CITY OF ALBUQUERQUE

**Re: McMahon Market Place Lot 2,
10680 Unser NW
Certificate of Occupancy – Transportation Development
Engineer's Stamp dated 08-06-13 (A11-D011A)
Certification dated 08-06-13**

The Letter of Certification submitted on 08-07-13 is not sufficient for acceptance by this office for Permanent Certificate of Occupancy (C.O.). The following items need to be addressed and completed:

A1.2

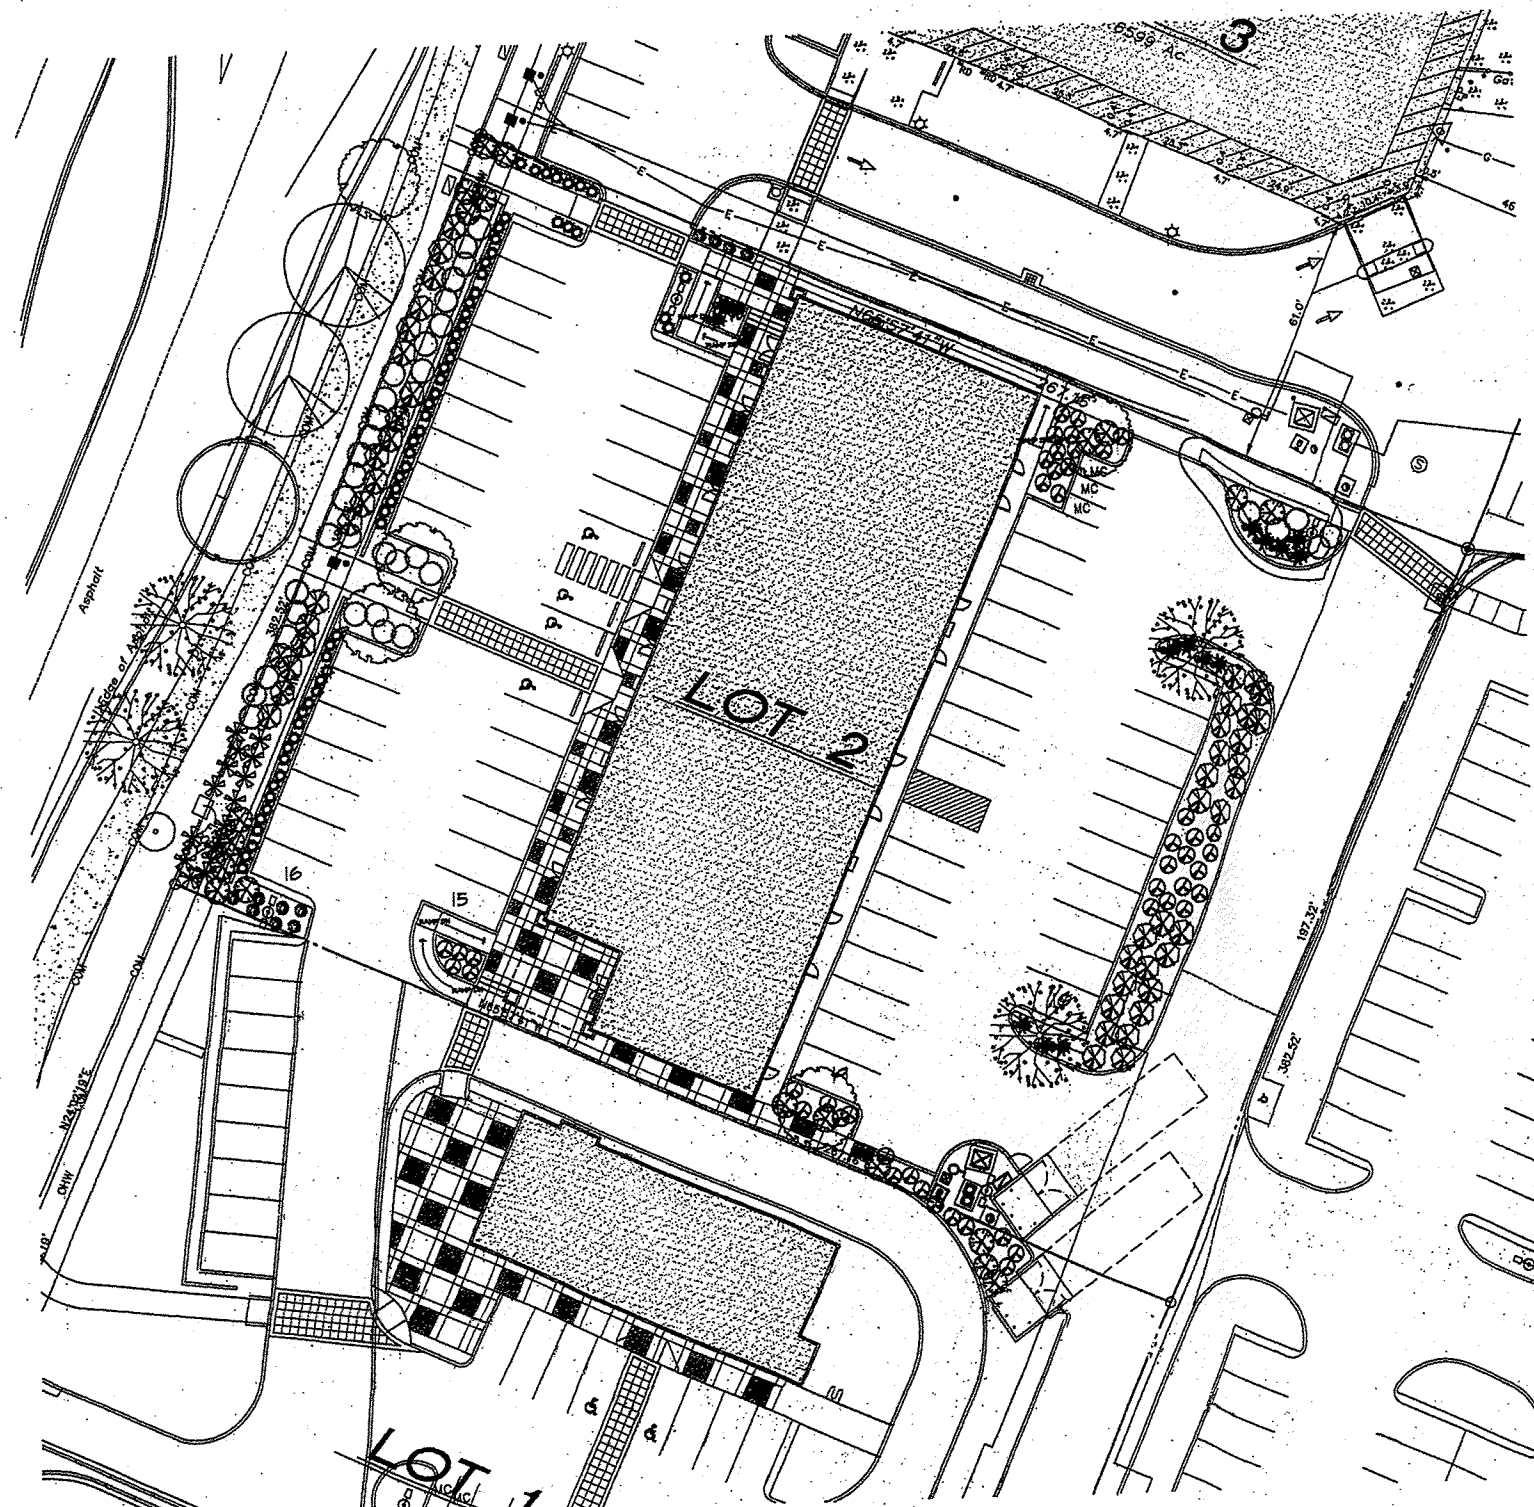
- Hand railing will need to be provided on both ramps as called out on Site Plan Sheet A1.2 Key Note 22.
- The barricading will need to be removed from entrance aisle to Unser and to the site.
